RECOMMENDED SERVICE BULLETIN

RSB 40-083

Replacement of steel pin of door handle mechanism of canopy and passenger door with an improved design.

WORK INSTRUCTION

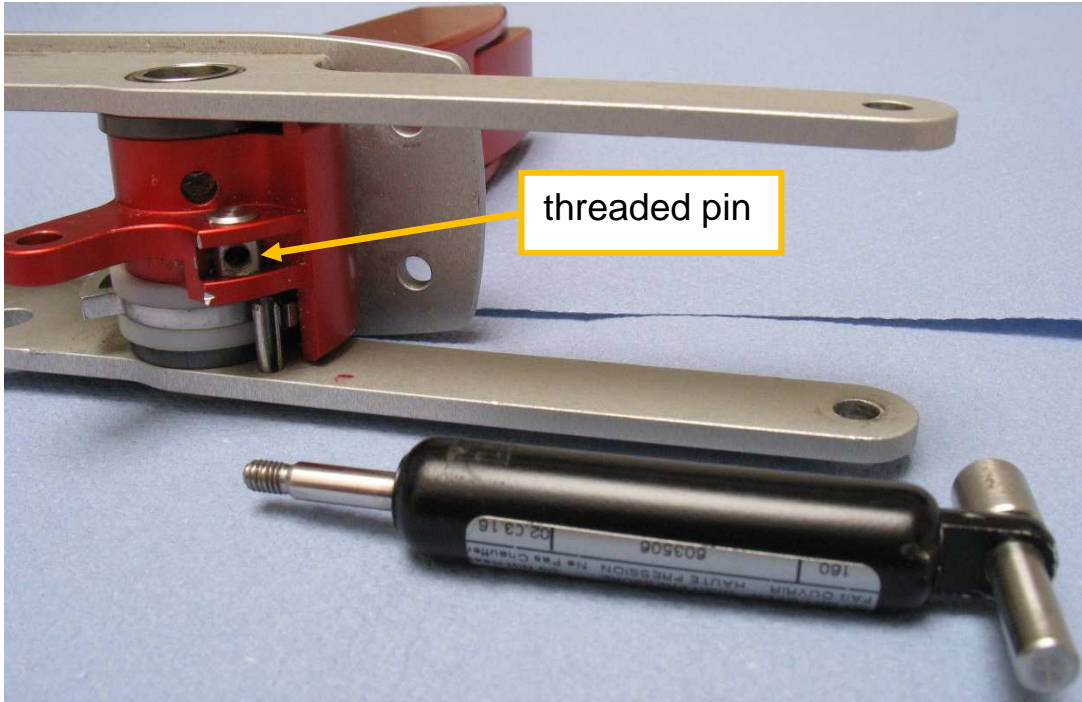
If necessary, replace the compression gas spring of the passenger door handle mechanism:

- Unscrew the piston of the compression gas spring from the threaded pin.
- Install the new compression gas spring to the threaded pin.

Note: Secure the thread of the compression gas spring with Loctite 243 when installing the new compression gas spring to the threaded pin.

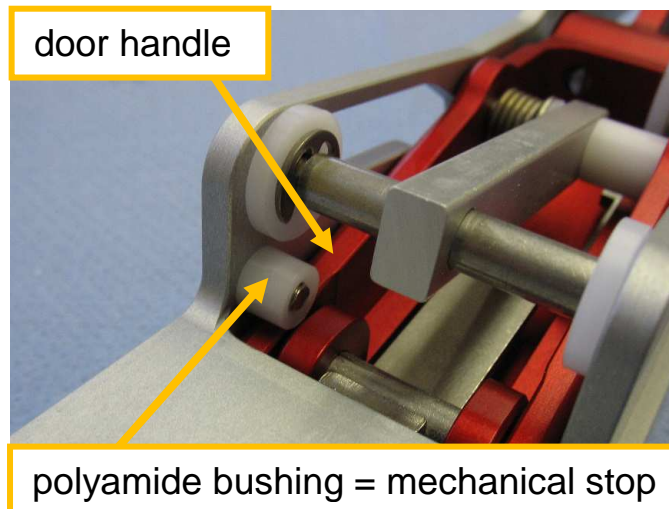
Adjust the length of the compression gas spring. Make sure that the polyamide bushing defines the mechanical stop of the red aluminum door handle as shown in the picture below.

Note: The mechanical stop of the red aluminum door handle must not be defined by the internal stop of the compression gas spring.

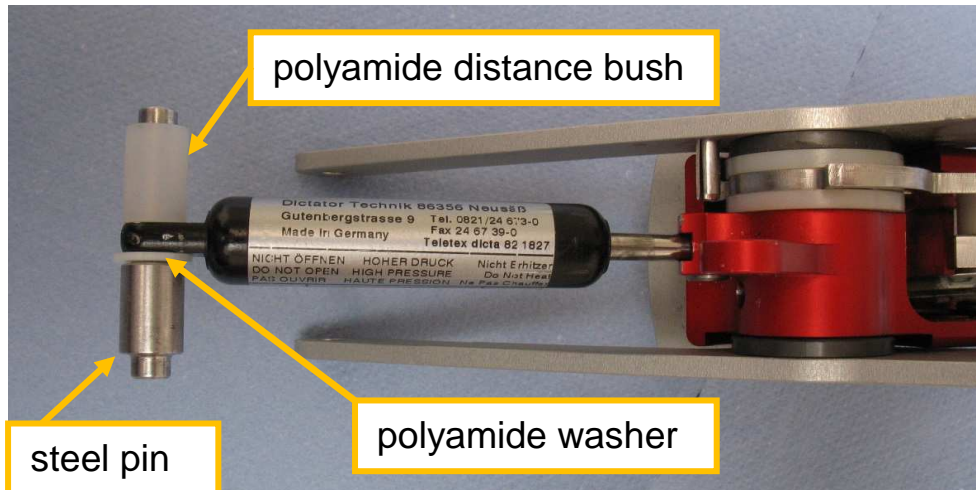
Prepare the new steel pin for installation into the door handle mechanism frame:

- Move the polyamide washer onto the new steel pin.
- Move the steel pin through the eye end of the compression gas spring.
- Move the polyamide distance bush onto the steel pin.

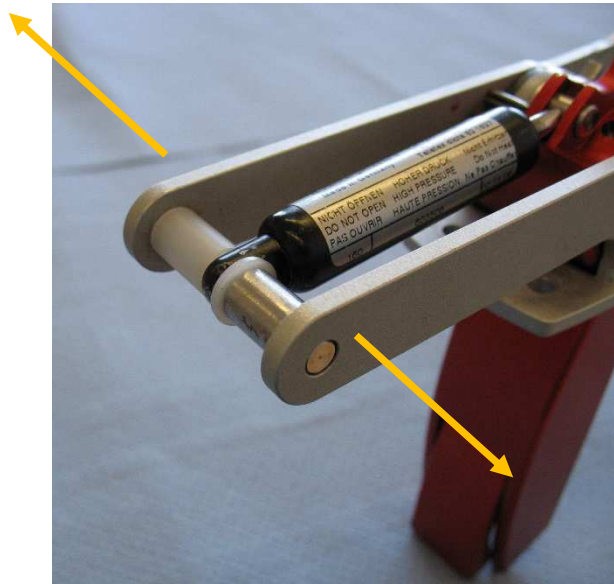
Install the new steel pin with the polyamide washer and the polyamide distance bush to the door handle mechanism frame:

- Move the steel pin into position.
- Carefully bend the side parts of the door handle mechanism frame away from each other as shown by the yellow arrows in the picture below so that the steel pin can snap into the holes of the side parts of the door handle mechanism frame.

Caution: Bend the side parts of the door handle mechanism frame away from each other only as far as necessary. If the side parts are bent too much and permanently deformed, the whole door handle mechanism must be replaced.
